MIL-A-18717B(AS)
AMENDMENT 1
27 August 1984

ARRESTING HOOK INSTALLATIONS, AIRCRAFT

This amendment forms a part of Military Specification MIL-A-18717B(AS), dated 10 September 1979, and is approved for use by the Naval Air Systems Command, Department of the Navy and is available for use by all Departments and Agencies of the Department of Defense.

Figure 1. Typical Arrangement and Details of Arrested Landing Deck Area on CV Type Flight Deck

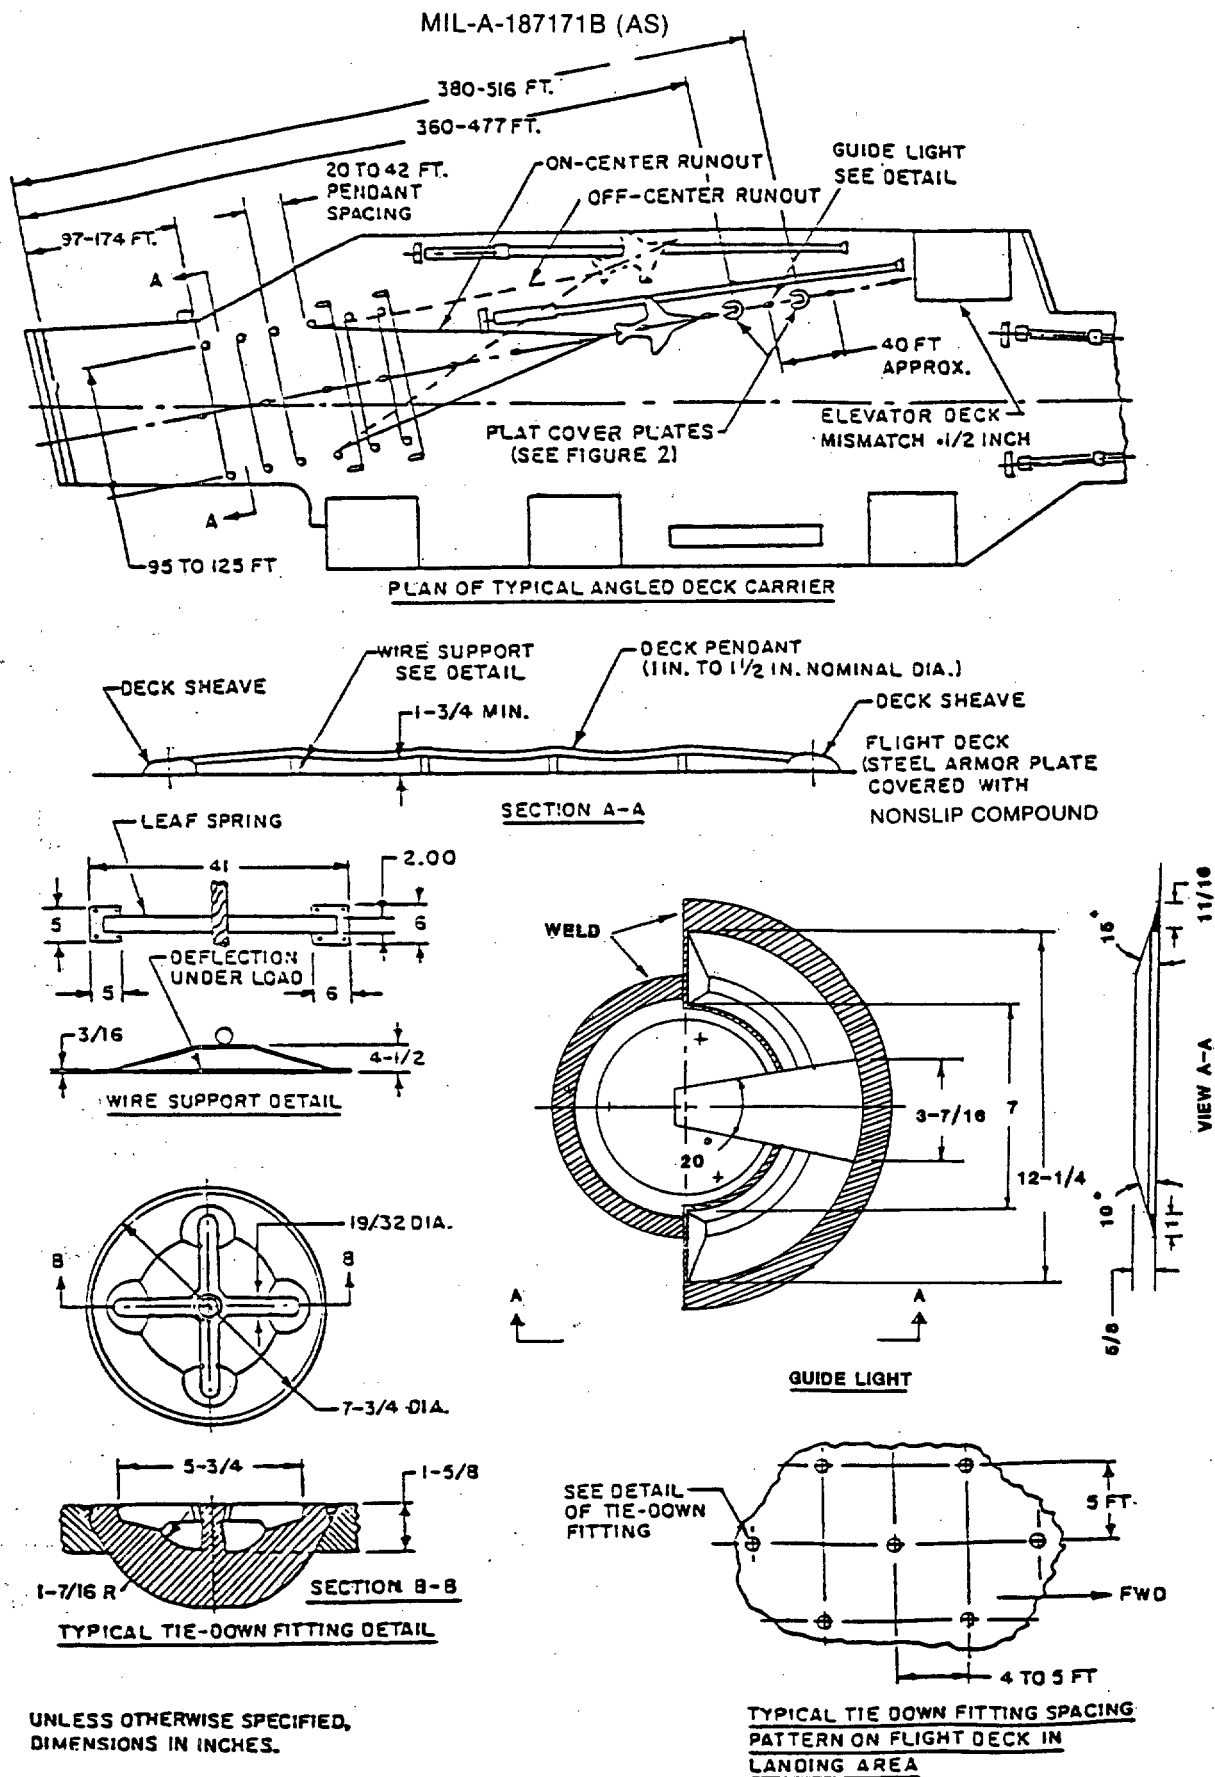
Delete entire Figure 1 and replace with revised Figure 1.

Figure 2. Pilot Landing Aid Television (PLAT) Installation

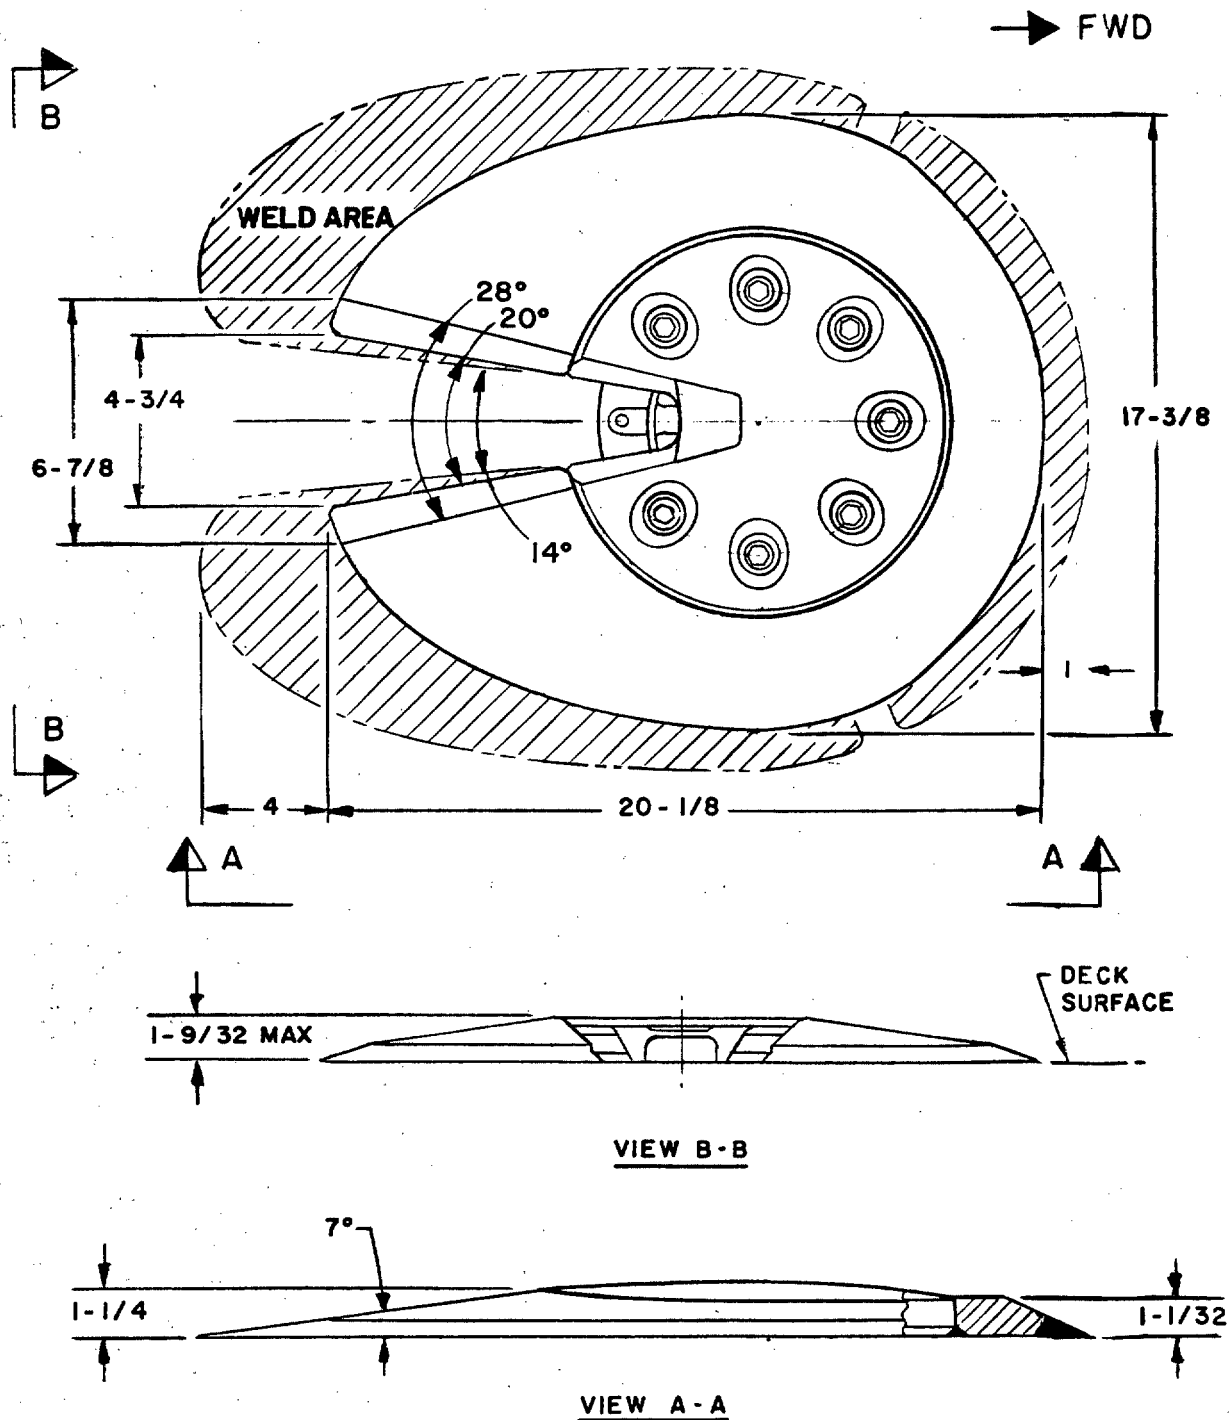
Delete entire Figure 2 and replace with revised Figure 2.

Revise Figure 2 title to read:

"Figure 2 Pilot Landing Aid Television (PLAT) Installation. . . .5."
